TECHNICAL NOTE

Our Ref: J10-14990A-10-R03-D01

SUBJECT: RESPONSE TO SCHEDULE 5 NOTICE FOR INFORMATION FOR THE CANFORD ENERGY FROM WASTE COMBINED HEAT AND POWER FACILITY (APPLICATION REF. EPR/SP3127SF/A001)

Figure 1: Heat demand within 15 km

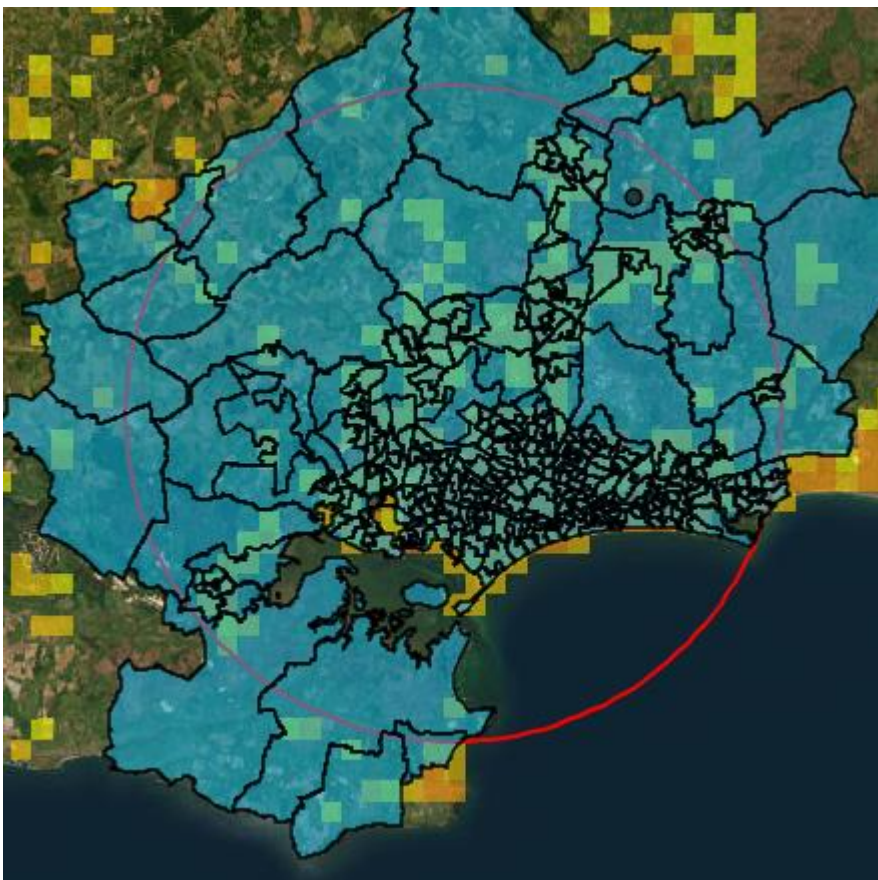
c) If 25 MWth cannot be supplied within 1.5 km justify whether it would be economically viable or feasible to supply heat to other users beyond 1.5 km and within 15 km of the installation. Note The CHP report states 'Appendix B and paragraph 5.1.2 show there is a potential heat demand substantially exceeding 25MWth within a wider 15 km area in line with the Energy Efficiency Directive guidance'. However Appendix B does not appear to show data beyond 1.5 km.

Table 1 demonstrates that the estimated total heat demand within 15 km is ~302 MWth. However, it is evident from this table and the subsequent map (Figure 1) that the majority of this demand is accounted for by a large number of small loads dispersed across a wide area, with more than 86% of the total demand accounted for by individual domestic properties. It is not technically nor commercially viable to establish such a large geographic network for multiple consumers for the level of available heat produced by the EfW CHP Facility.

Large point source heat load consumers are generally more viable as it allows a single length of pipe work and trenching to be installed between the producer and consumer. However, Figure 1 demonstrates that there is only a single large heat load within 15 km (dark green dot). This is located approximately 14 km to the north-east of the EfW CHP Facility and is described by the BEIS CHP tool as an “Unknown Operator” with an estimated heat demand of ~6 MWth.

Further inspection of this location indicates it may relate to Veolia’s Chatsworth Blue Haze Landfill. It is unclear why a landfill would require a heat demand of 6 MWth. Veolia recently submitted an application to introduce a temporary incinerator bottom ash (IBA) processing facility at this location but, again, it is unclear whether an IBA processing facility would have a heat demand of 6 MWth.

Notwithstanding the above, installation of a heat network to provide 6 MWth of heat at a distance of 14 km would not be economically viable. The cost-benefit analysis supporting the CHP-R assessment submitted with the application

demonstrated a negative NPV for a 5 MWth heat network within 1.5 km. Costs for additional trenching and pipe work alone would be expected to be an order of magnitude greater for a distance approaching 15 km and this would be expected to make the NPV even more negative despite the slightly increased heat sales.

Consequently, it is not considered feasible to supply heat to consumers beyond 1.5 km and up to 15 km from the EfW CHP Facility.

Figure 3: Unweighted daytime noise contours (normal operation)

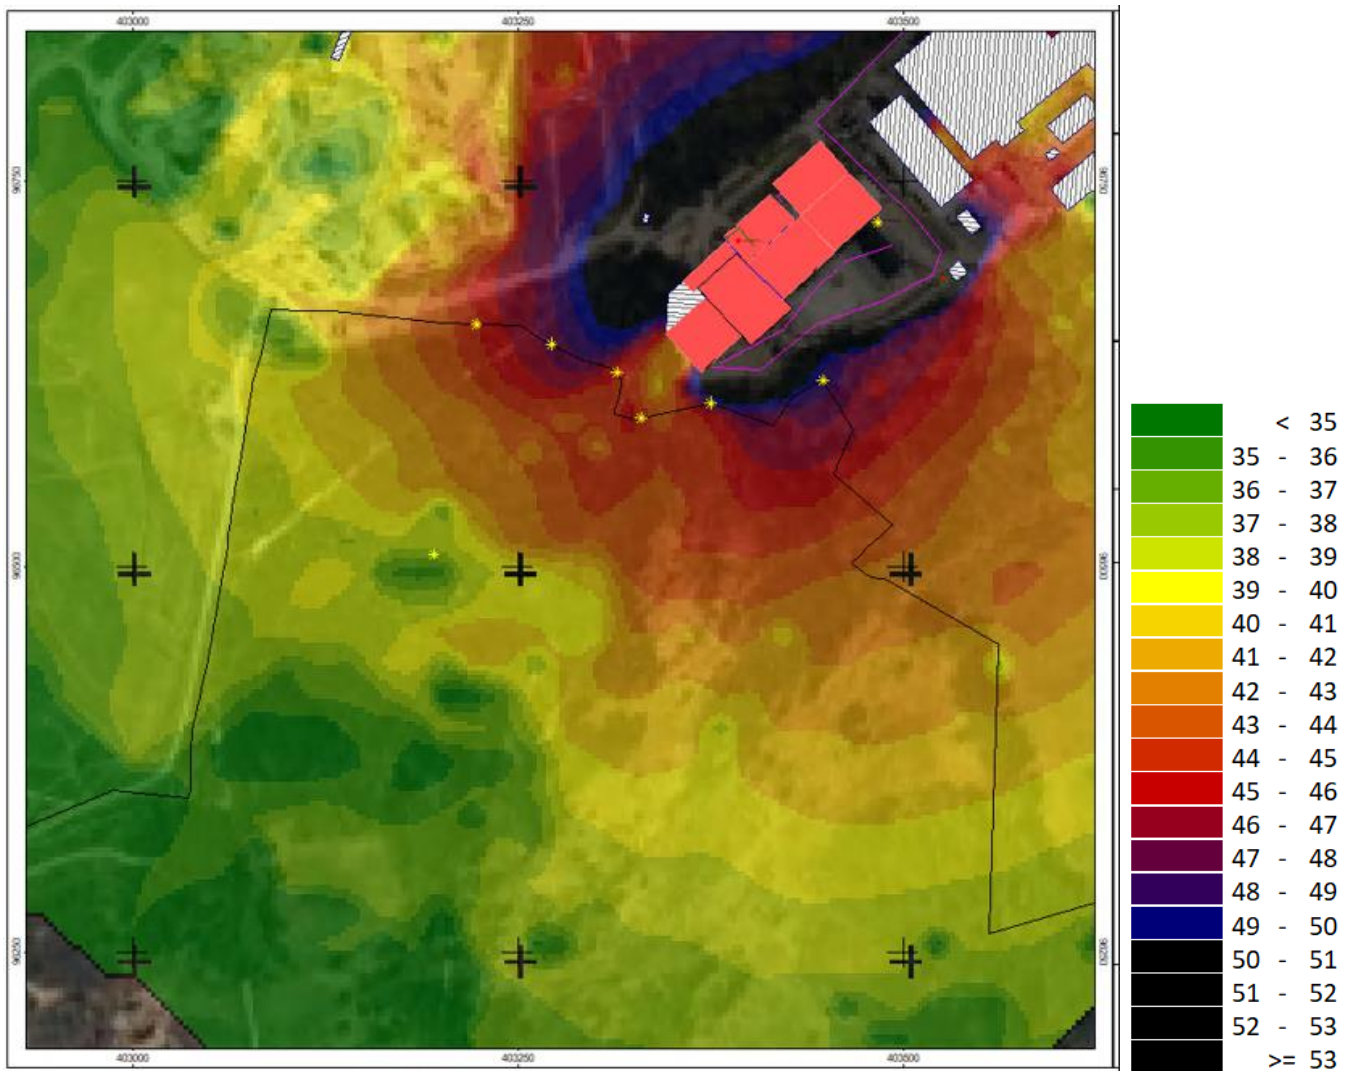
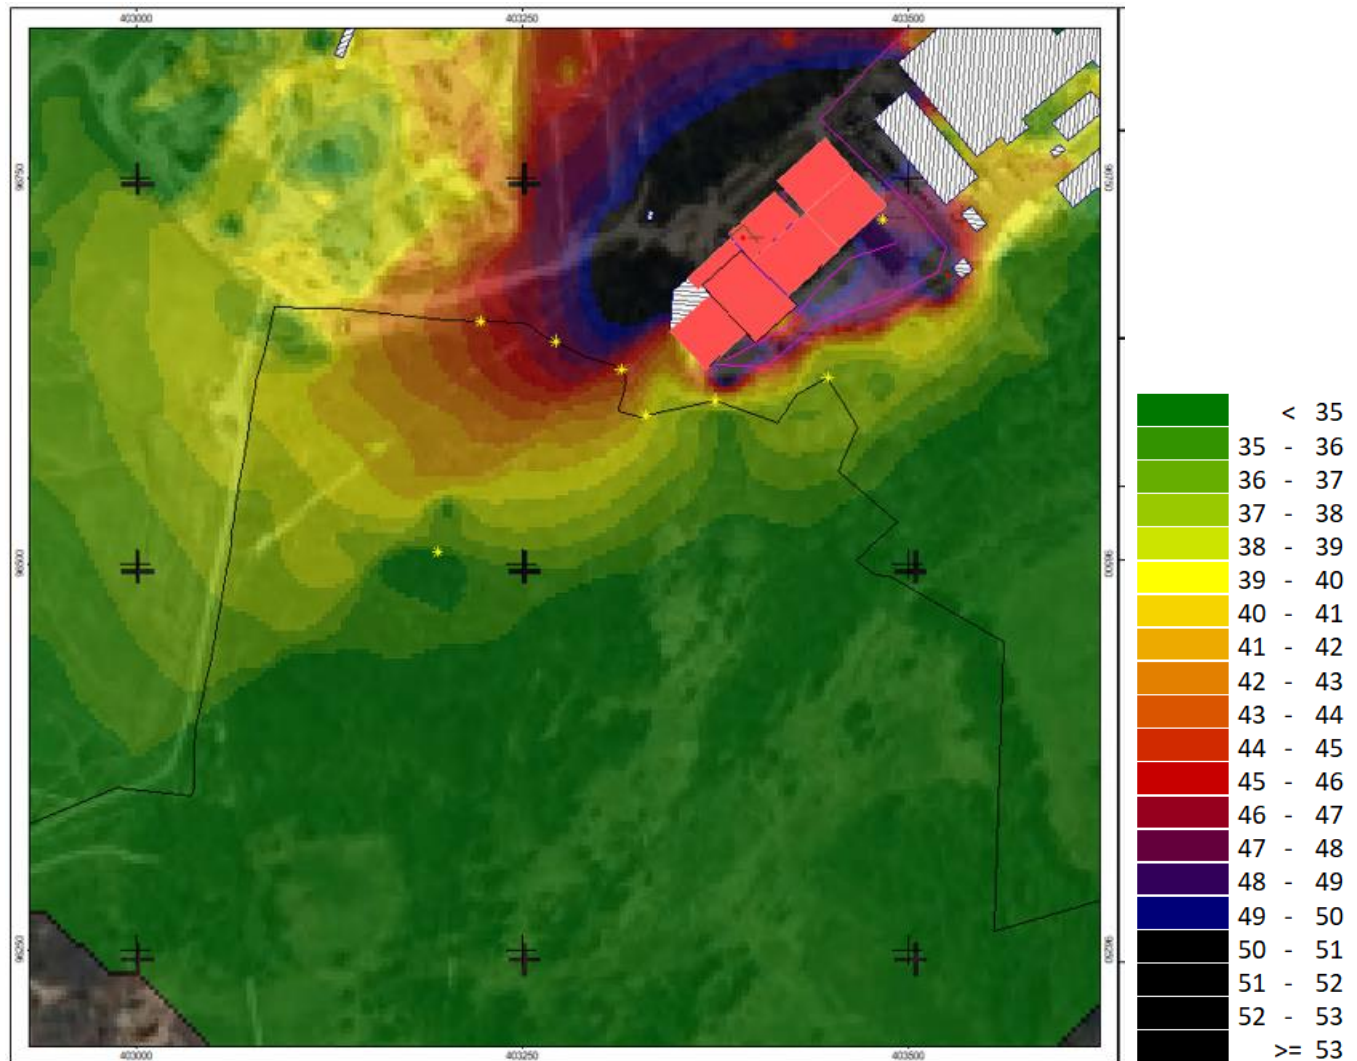
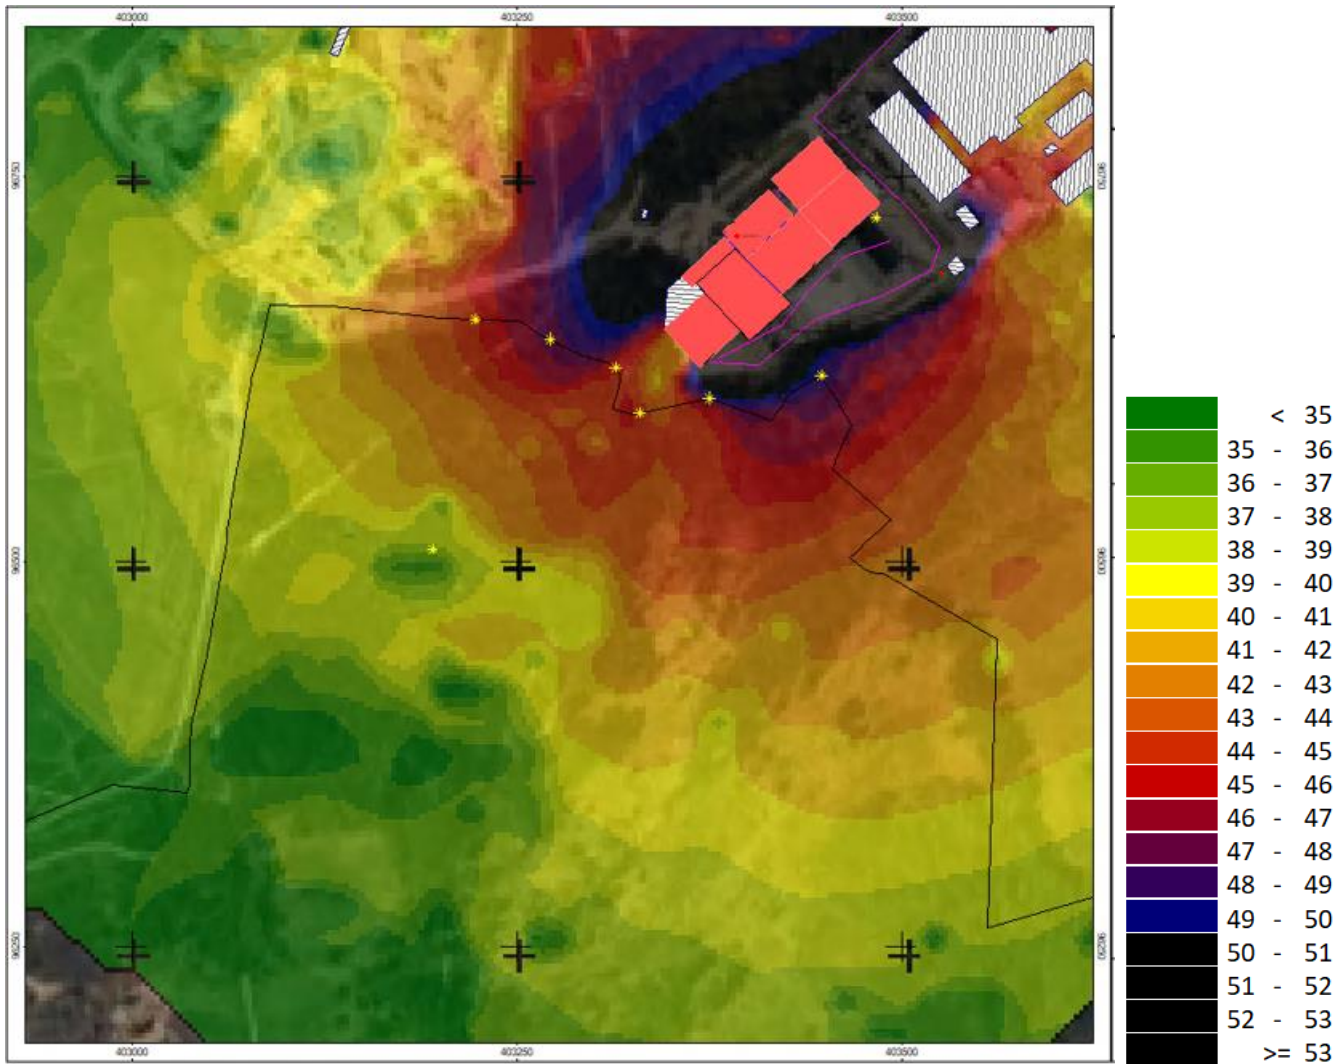
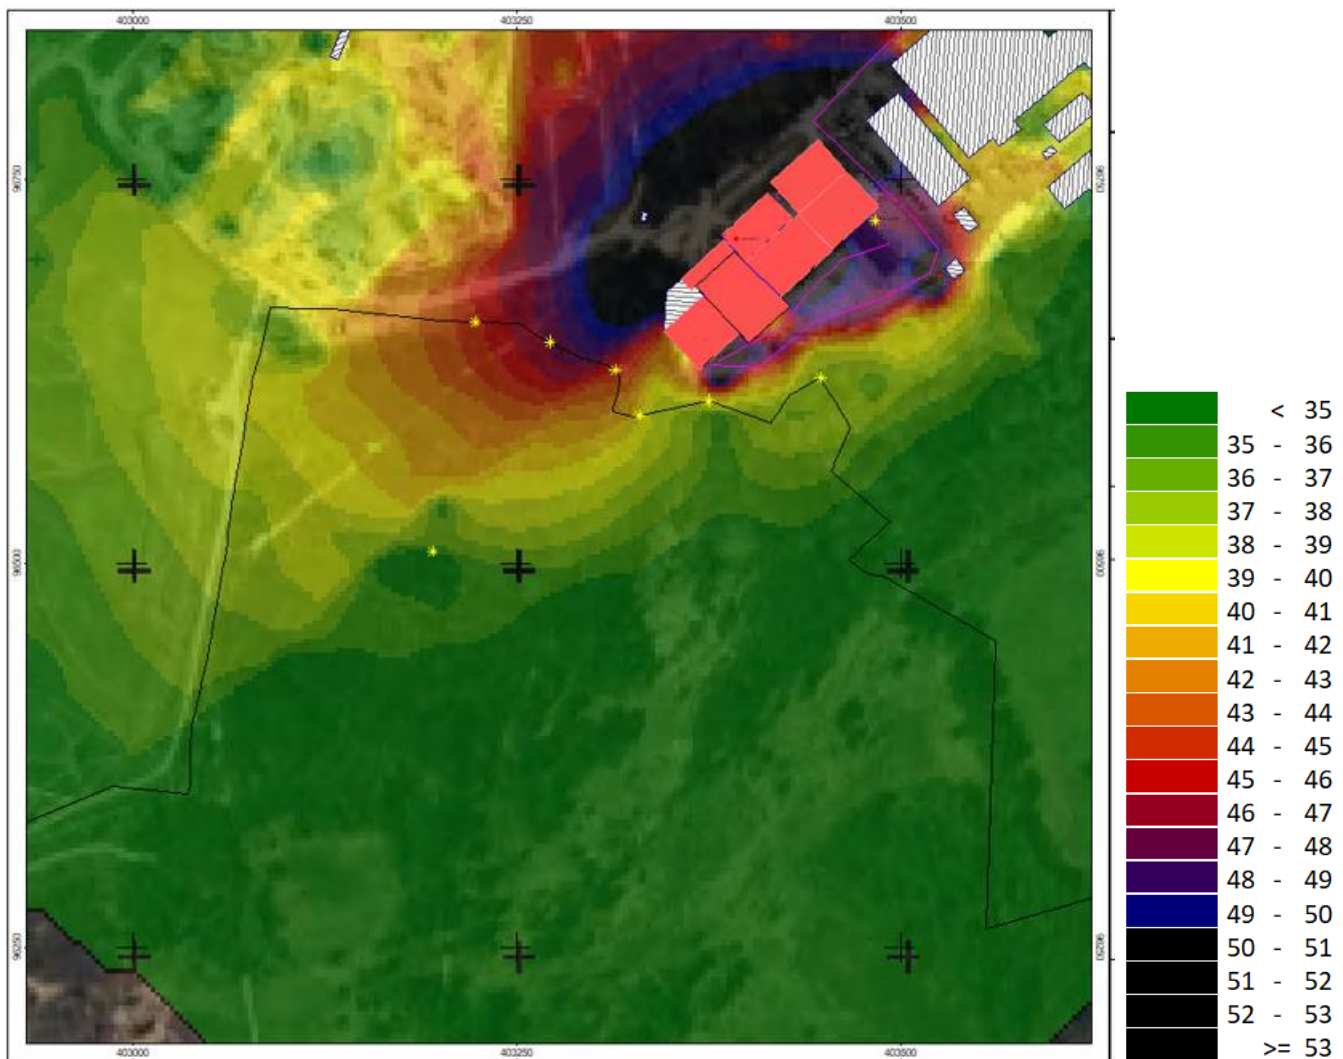
5. Provide an assessment of the unweighted noise levels produced by the installation at the boundary of Dorset Heathlands SPA (adjacent to the installation boundary) and their potential to cause disturbance of the SPA designated features. Note : The receptor location used to assess noise as part of the BS4142 noise impact assessment (R22) is some way into the SPA and as such will not be conservative of impacts in the nearest area of habitat.

Response: Predictions of both the unweighted (dBZ) and A-weighted (dBA) noise rating levels at a series of receptors along the edge of the SPA adjacent to the installation boundary are provided in the table below. Noise contours are also presented in Figure 3 through Figure 6. These predictions have been made using the latest calculation methodology in the 2024 version of ISO 9613-2.
